**Comments on the planning application for the proposed Field
Study/Education/Visitor Centre at Pak Lap (A/SK-PL/1)**

The Hong Kong Bird Watching Society (HKBWS) objects to the planning application based on the following reasons.

Figure 1. Instead of choosing a proper vantage point that hikers could really see the application site from the hiking trail (Upper), the applicant picked a vantage point that the site could not be seen (Bottom).

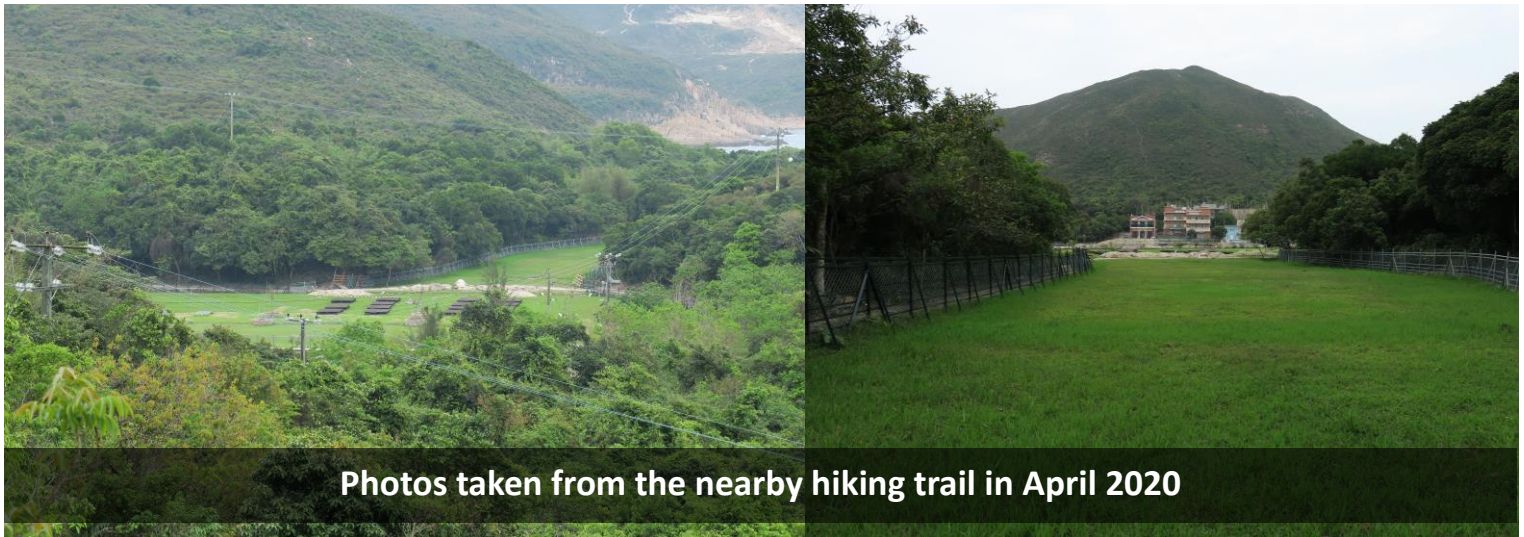
- 2.3 During the operation phase, the two large building blocks with 4-storey high are clearly incompatible with the surrounding fallow farmlands and rural environment, which is generally 2 to 3-storey high. However, from the provided photomontages, instead of choosing a proper vantage point that hikers could really see the application site from the hill along the hiking trail (Figure 1), the applicant picked a vantage point that the site could not be seen. We consider the visual impact assessment is misleading and there are clearly irreversible visual and landscape impacts on the Country Park and

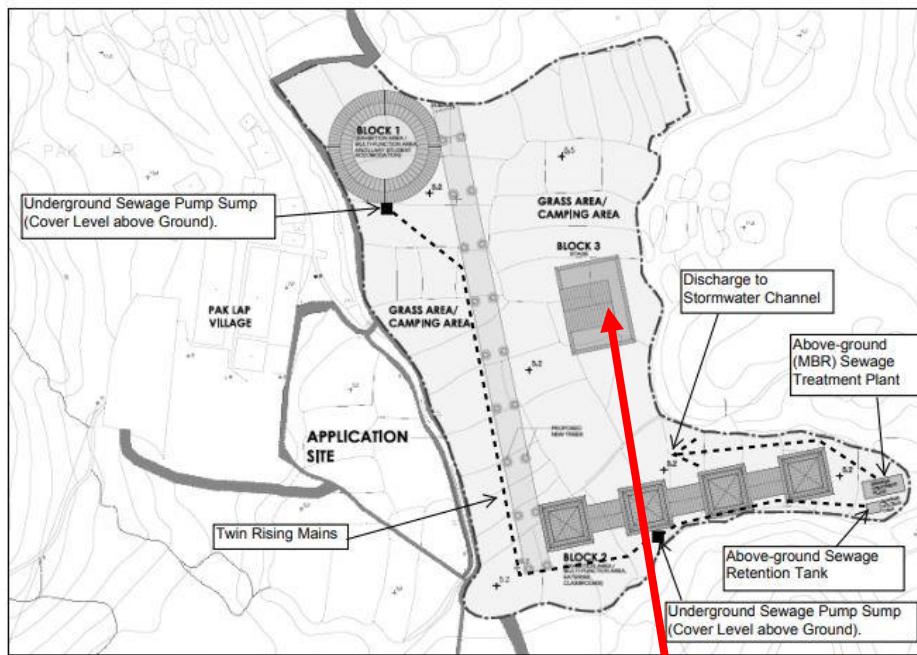
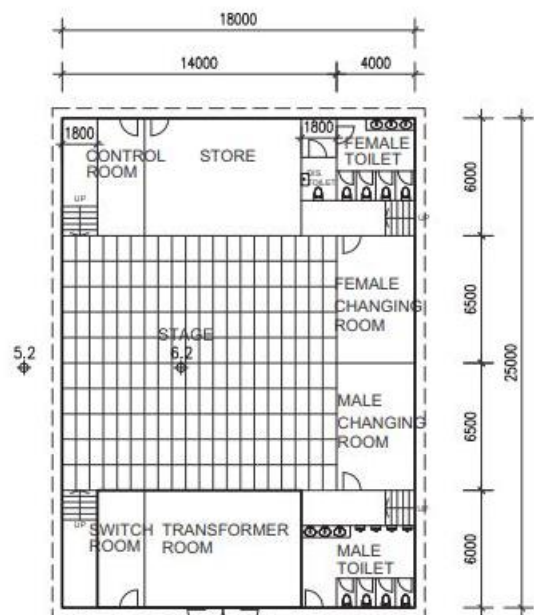
- 2.6 The sewage layout plan in Figure 2 of the Sewerage Drainage Impact Assessment indicate that there is **NO** sewage pump sump and pumping mains connecting to the proposed sewage treatment plant for Block 3, which was planned to have changing rooms and both male and female toilets (including disabled toilets) according to the planning statement and layout plan for Block 3 (Figure 2). It is unclear if the sewage impact assessment has also taken them into account, and how would those generated sewage be treated.

Figure 2. The sewage layout plan (Upper) indicate that there is **NO** sewage pump sump and pumping mains connecting to the proposed sewage treatment plant for Block 3, **which was planned to have changing rooms and both male and female toilets** (including disabled toilets) according to the planning statement and layout plan for Block 3 (Bottom). It is unclear if the sewage impact assessment has also taken them into account, and how would those generated sewage be treated.
